Access Compliance Report

Public Rights-of-Way (Curb Ramps)

Intersection ID: 3539	Main Street: HARRIS_CORNERS_PY	Cross Street: MAPLE_VIEW_LN	Location: NW
ADA ID: 640F2896462E	Ramp Type: Perp	Initial Pass/Fail: Fail	Overall Compliance: No
		Severity Score: 12.5

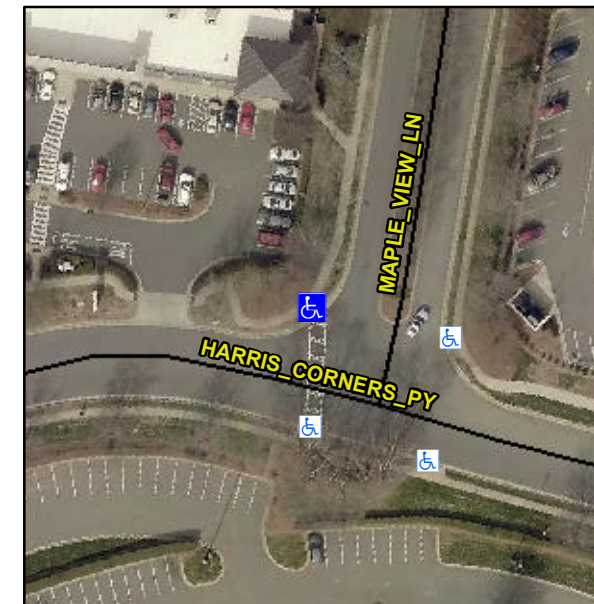
R304.2.2

Compliance	Description	Data	Compliance	Description	Data
N/A	Ramp Length (in)	48.5	No	Ramp Slope (%)	8.4
Yes	Ramp Width (in)	48.0	Yes	Ramp XSlope (%)	1.1
N/A	Flare Type LT	N/A	N/A	Flare Type RT	N/A
N/A	Flare Slope LT (%)	N/A	N/A	Flare Slope RT (%)	N/A
N/A	Flare Traversable LT?	N/A	N/A	Flare Traversable RT?	N/A
N/A	Landing Length (in)	N/A	N/A	DWS Provided?	N/A
N/A	Landing Width (in)	N/A	N/A	DWS Contrast?	N/A
N/A	Landing Slope (%)	N/A	N/A	DWS Length (in)	N/A
N/A	Landing X Slope (%)	N/A	N/A	DWS Full Width?	N/A
N/A	Landing Curb? (Y/N)	N/A	N/A	DWS Offset (in)	N/A
N/A	Shared Landing?	N/A			
N/A	Gutter Ponding?	N/A	N/A	Gutter Slope (%)	N/A
N/A	Gutter Lip Ht (in)	N/A	N/A	Gutter X Slope (%)	N/A
N/A	Painted X Walk1?	Yes	N/A	Painted X Walk2?	N/A
	X Walk 1 Direction	To S		X Walk 2 Direction	N/A
N/A	X Walk 1 Width (in)	85.0	N/A	X Walk 2 Width (in)	N/A
	X Walk 1 Slope (%)	0.1		X Walk 2 Slope (%)	N/A
	X Walk 1 X Slope (%)	0.1		X Walk 2 X Slope (%)	N/A

Remove & Replace Entire Ramp.
